# SERVICE BULLETINS

RE.	PRODUCT
GEARBOX	P
M 30, M 40	GROUP
	43
DATE	NO.
15th June 1962	1

## Concerning shrill noise from the synchronizing cones.

Shaded portion removed

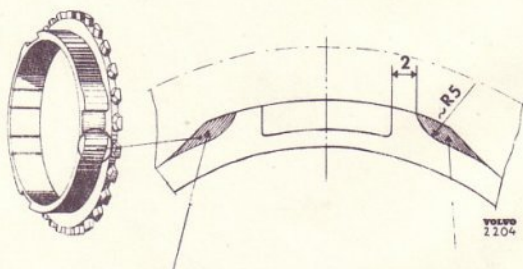
Cases have occurred on the above-mentioned gearboxes of a shrill and piecing noise arising as a result of a vibrating synchronizing cone. In order to remedy this, it may be necessary to introduce unbalance to the cone which vibrates. This is done by removing material from both sides of one groove as shown in the figure.

In order to determine which cone is causing the trouble, the following points should be noted:

1. If the noise occurs when driving in 1st or 2nd speed, it is generally the 3rd or 4th speed cone which vibrates.
2. Noise occurring when driving in 3rd or 4th speed usually comes from the 1st or 2nd speed cone.
3. On a cone that vibrates, greater wear occurs at the groove edges after driving for a relatively short time than on a cone that does not vibrate.
